Wisconsin Department of Transportation

Proposal #04: 1206-04-63, WISC 2016 219
Sauk City - Cambridge
Yahara River B-13-0315 and B-13-0316
USH 12
Dane County

This is Addendum No. 01, which provides for the following:

ADDENDUM NO. 01

Revised Sheet 17

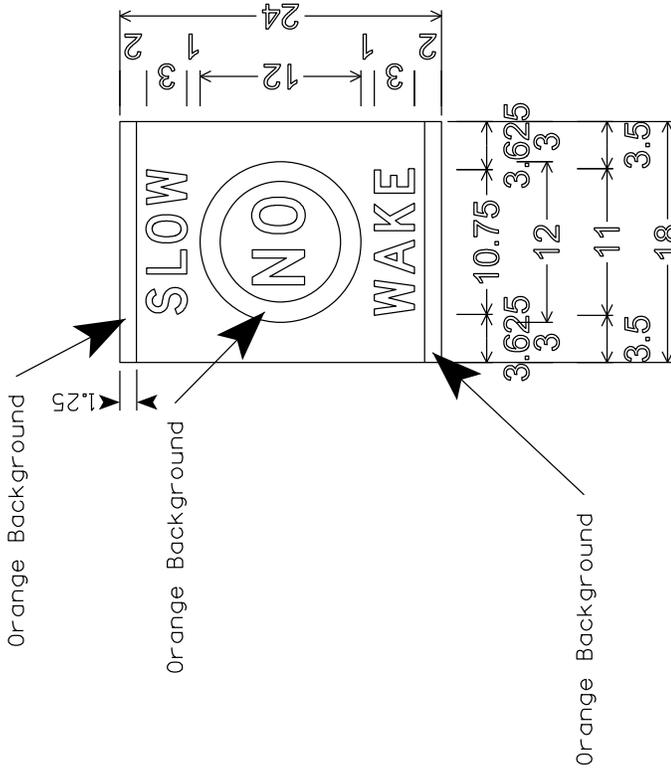
Revised Plan Sheets	
Plan Sheet	Plan Sheet Title (brief description of changes to sheet)
17	Miscellaneous Quantities (added quantity)
56	General Plan 1 of 3 (revised quantity)
59	Cross Section & Quantities (revised Pier 32 quantity)
60	General Plan 1 of 3 (revised quantity)
63	Cross Section & Quantities (revised Pier 32 quantity)

LOCATION	MESSAGE	QTY	SIZE	628.2602 REMOVING SIGNS TYPE II EACH	637.2210 SIGNS REFLECTIVE H SF
WATERWAY SIGNING	SLOW NO WAKE	4	24"X18"	4	12
TOTAL				4	12

Addendum No. 01
ID 1206-04-63
Added Sheet 55B
May 17, 2016

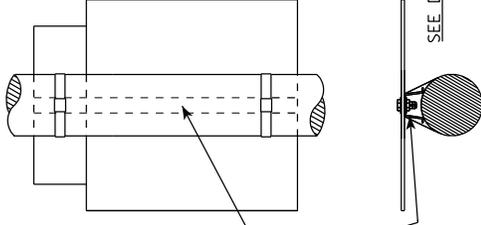
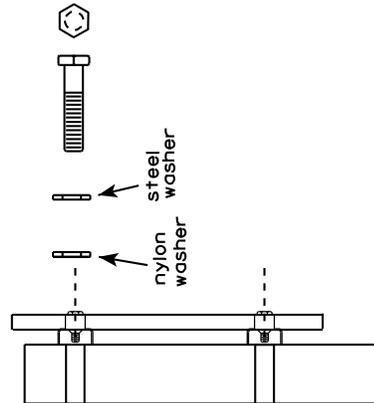
Added Plan Sheets	
Plan Sheet	Plan Sheet Title (brief description of changes to sheet)
55A	Sign (for added "slow no wake signs)
55B	Standard Sign - Sign Banding Details (for added "slow no wake" signs)

Addendum No. 01
 ID 1206-04-63
 Revised Sheet 56
 May 17, 2016

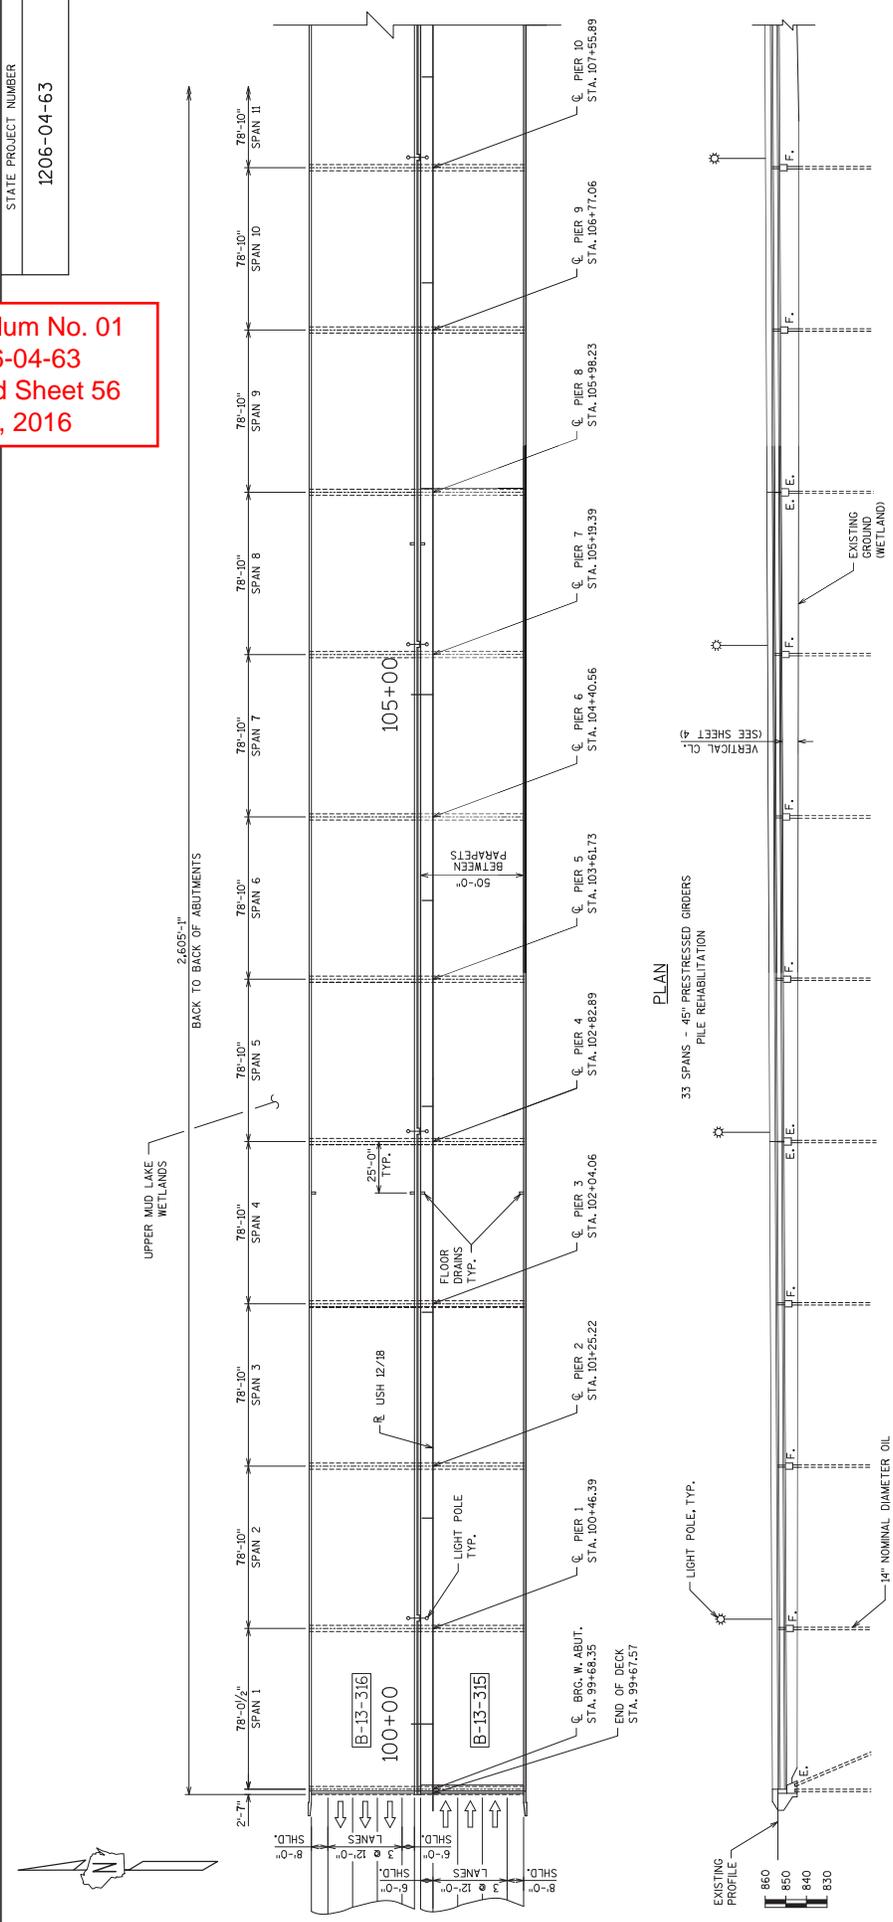
NO.	DATE	PILE REHABILITATION QUANTITY	REVISION	BY
1	5-10-16

BID. ITEM	DESCRIPTION	UNIT	TOTAL
SPV-0060.01	PILE REHABILITATION	EACH	379
TOTAL ESTIMATED QUANTITIES

Addendum No. 01
ID 1206-04-63
Revised Sheet 60
May 17, 2016

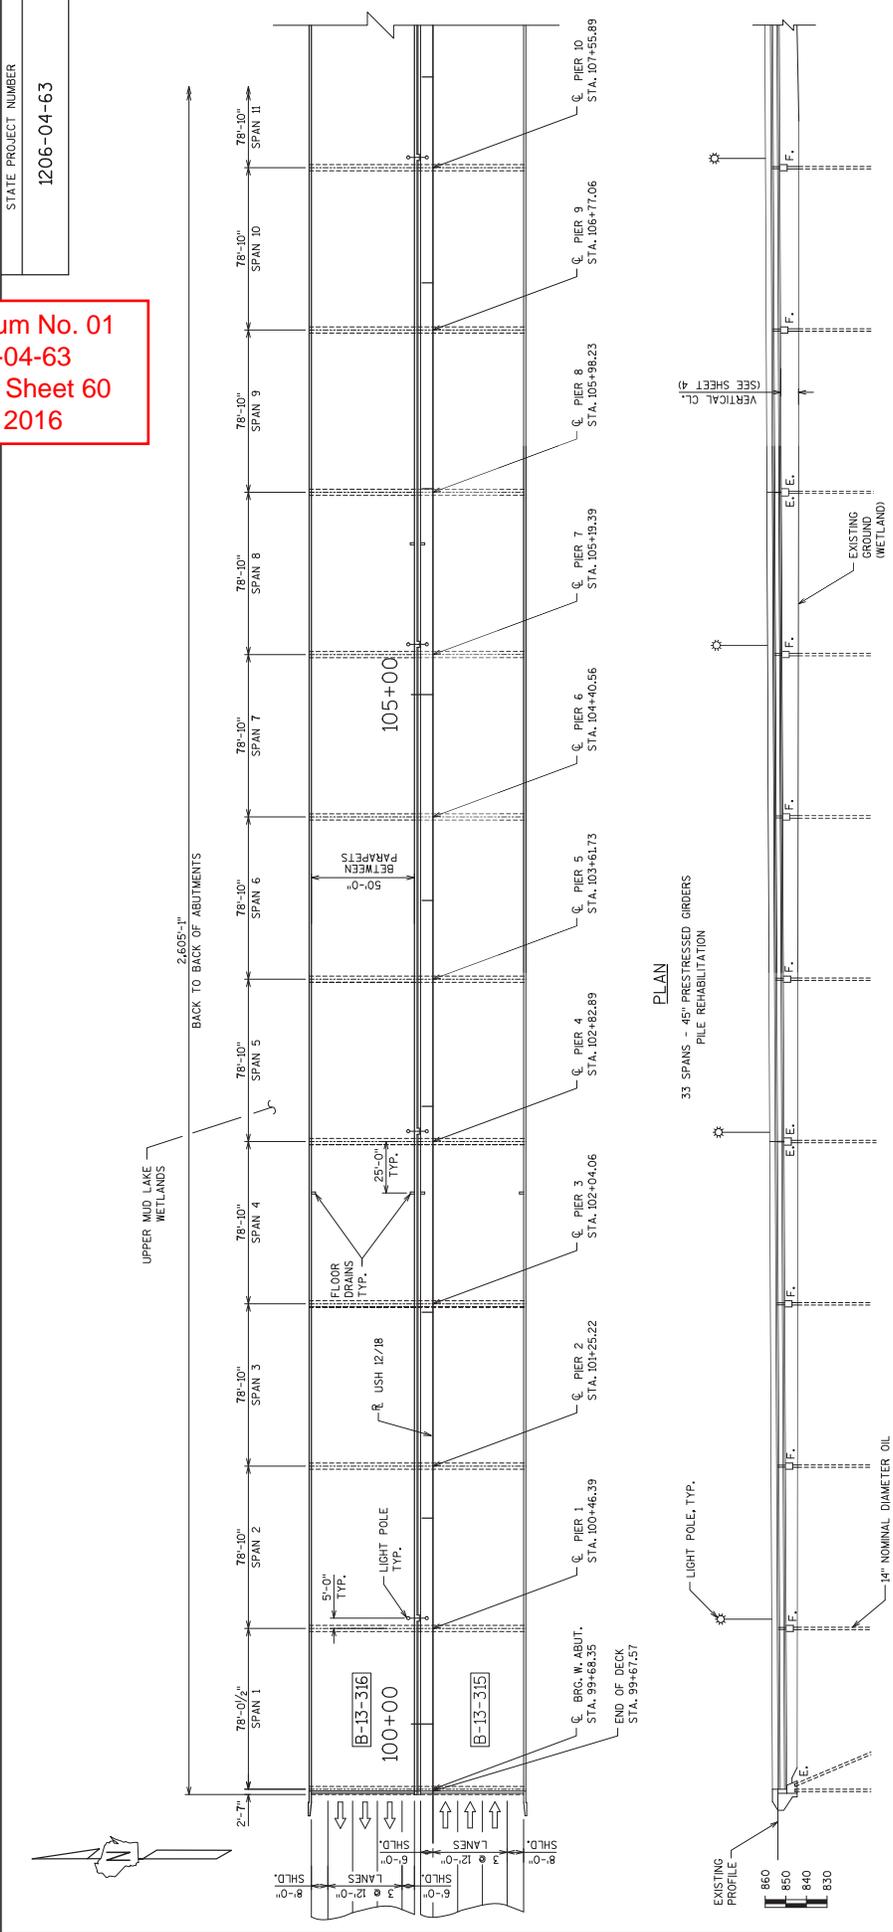
1	5-11-16	PILE REHABILITATION QUANTITY	JOB NO.	DATE	REVISION	BY
<p>AECOM</p> <p>15855 N. RiverCenter Drive Suite 200 Milwaukee, WI 53212 (414) 944-6080</p> <p>STATE OF WISCONSIN DEPARTMENT OF TRANSPORTATION</p> <p>ACCEPTED: CHIEF STRUCTURES DESIGN ENGINEER DATE</p> <p>STRUCTURE B-13-316</p> <p>WB USH 12/18 (BELTLINE) OVER YAHARRA RIVER</p> <p>COUNTY: DANE TOWN/CITY/VILLAGE: MONONA</p> <p>DESIGN SPEC.: REHABILITATION N/A</p> <p>DESIGNED BY: JDB MJC MAD BRN JOB CDD. MAD</p> <p>PLANS SHEET 1 OF 4</p> <p>GENERAL PLAN 1 OF 3</p> <p>SHEET 60</p>

BID ITEM	DESCRIPTION	UNIT	TOTAL
SPV.0060.01	PILE REHABILITATION	EACH	403
